## **REWORK FIELD SERVICE BULLETIN**

FSB Number	CHRAEFSB2017-33
Author	Tony Bryan
Date	09/07/2017
Subject	Moto Z2 Play - Turn On/Off - Battery Wire Routing/Damage
Model Affected	XT1710 (All)
Level Of Repairs	Level 1

**Figure 1.0 - Battery Wire Routing**

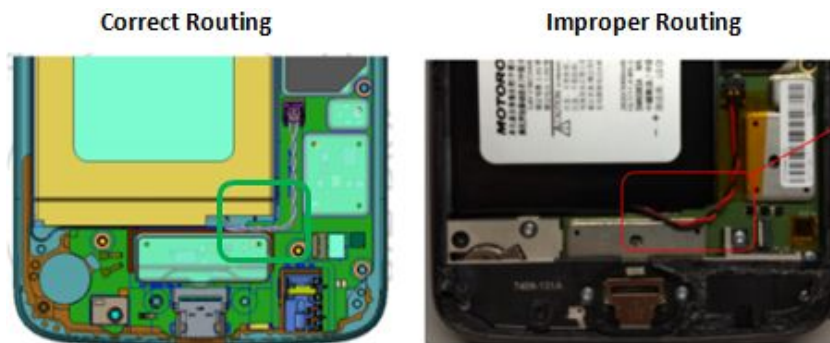
Motorola is aware of a potential customer experience issue on the Moto Z2 Play product related to Turn On/Off issues. Some users reported that their Moto Z2 Play device would randomly power itself off and/or not power on. Engineering analysis of the returned devices found that the Battery Wires were not properly routed during initial assembly. See Figure 1.0 below.

In this case, the improperly routed Battery Wires rest on top of PCBA Shield (SH500) and will be further pressed against the shield once device is fully assembled causing damage to the rubber insulation, and resulting in a potential short circuit. See figure 2.0 below.

1. Carefully inspect the Battery Wires for proper routing, reference Figure 1.0 above.
  - a. If Battery Wires are routed properly, then:

**Figure 2.0 - Battery Wire Damage**

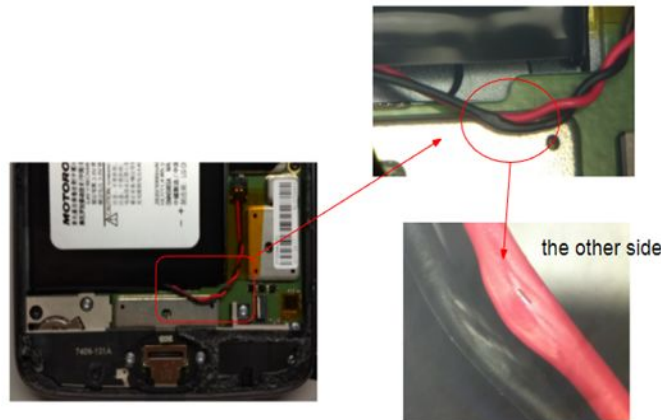
- A soft short will affect battery impedance and result in erratic battery metering and/or

- random power downs if Battery Safety Circuit is tripped.
- A hard short will result in device no longer powering up.

Global Service Team may choose to implement an offline Microscope Inspection Process to carefully inspect all replaced HZ40 Battery Packs [P/N: SNN5983A] for any sign of wire damage, reference Figure 2.0 above.

- If any sign of Battery Wire damage is found under microscope inspection, then HZ40 Battery Pack [P/N: SNN5983A] must be scrapped.
- If Battery Wire damage is not found under microscope inspection, then HZ40 Battery Pack [P/N: SNN5983A] may be reused.

**Figure 3.0 - New Kapton Tape Placement [P/N: SD78C22444 (Old Ref P/N: 11017623093)]**

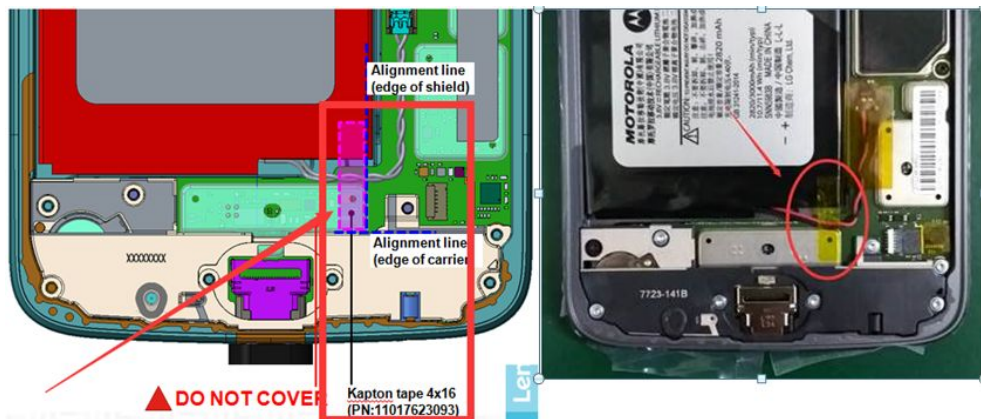
- New Part Added to BOM: 4mmx16mm Kapton Tape [P/N: SD78C22444 (Old Ref P/N: 11017623093)] which is placed across SH500 to guide wires around the PCBA Shield SH500. See Figure 3.0 below for details on proper placement.

- i. Place 4mmx16mm Kapton Tape [P/N: SD78C22444 (Old Ref P/N: 11017623093)], reference Figure 3.0 above.
- ii. Proceed with normal Repair Process
- b. If Battery Wires are improperly routed, then:
  - i. Replace the HZ40 Battery Pack [P/N: SNN5983A]
  - ii. Place 4mmx16mm Kapton Tape [P/N: SD78C22444 (Old Ref P/N: 11017623093)], reference Figure 3.0 above.
  - iii. Proceed with normal Repair Process

**Figure 4.0 - X-Ray Limit Examples**

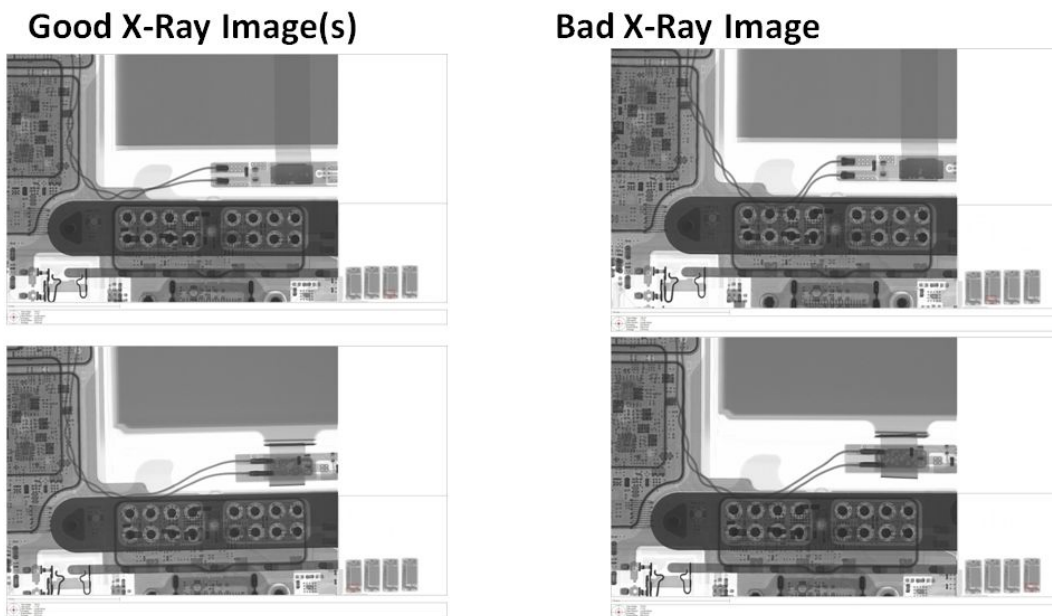
If access to X-Ray Machine is available, then this can be used to 100% screen devices for this issue at incoming prior to disassembly. See Figure 4.0 below for limit examples.
